# CITY OF ALBUQUERQUE

**Re: L & C Transport Office and Shop/ Building A & B**  
**112 94<sup>TH</sup> St. NW**  
**30-Day Temporary Certificate of Occupancy**  
**Transportation Development Final Inspection**  
Engineer's Stamp dated 08-03-21 (K09-D043)  
Certification dated 02-27-23

# ADMINISTRATIVE AMENDMENT

1 Site Plan  
1" = 20'-0"

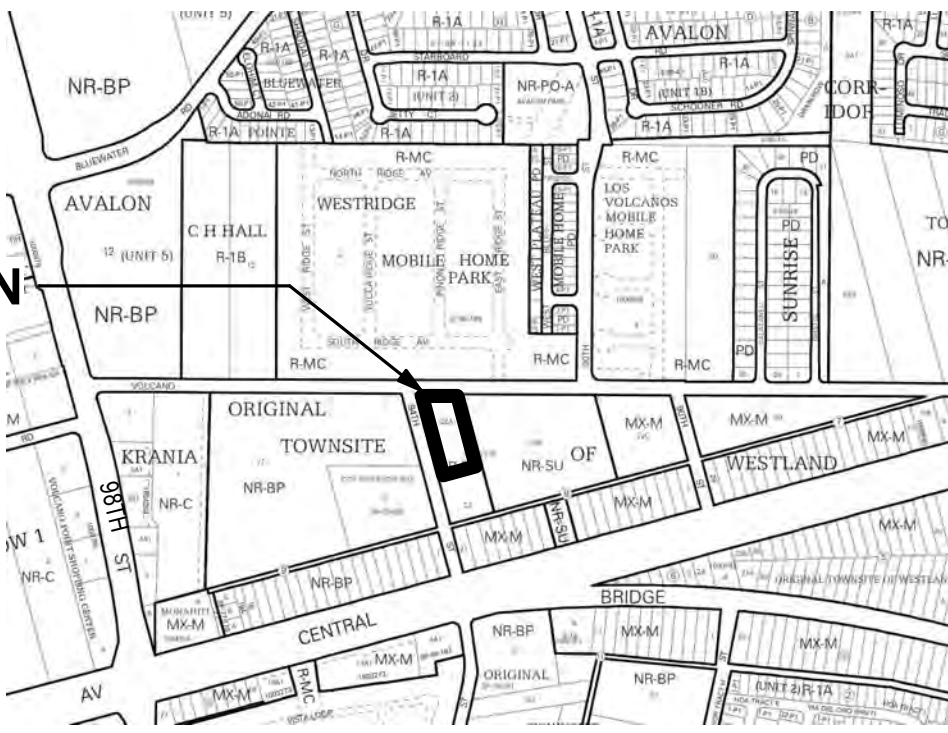
- Due to the closed gate, I couldn't measure the parking spaces.
- Please provide Motorcycle parking space. 1. Motorcycle parking spaces shall be designated by its own conspicuously posted upright sign, either free-standing or wall mounted per the zoning code. 2. The pavement marking "MC" should be shown in the opposite direction for motorcycles entering the parking space.

- The ADA access aisles shall have the words "**NO PARKING**" in capital letters, each of which shall be at least one foot high and at least two inches wide, placed at the rear of the parking space so as to be close to where an adjacent vehicle's rear tire would be placed. (66-1-4.1. B NMSA 1978)

- Per approved site plan key note 03200.46: provide 6' wide ADA pathway from the public sidewalk to the building entrance.
- Driveway access off 94<sup>th</sup> must be built per approved plan.
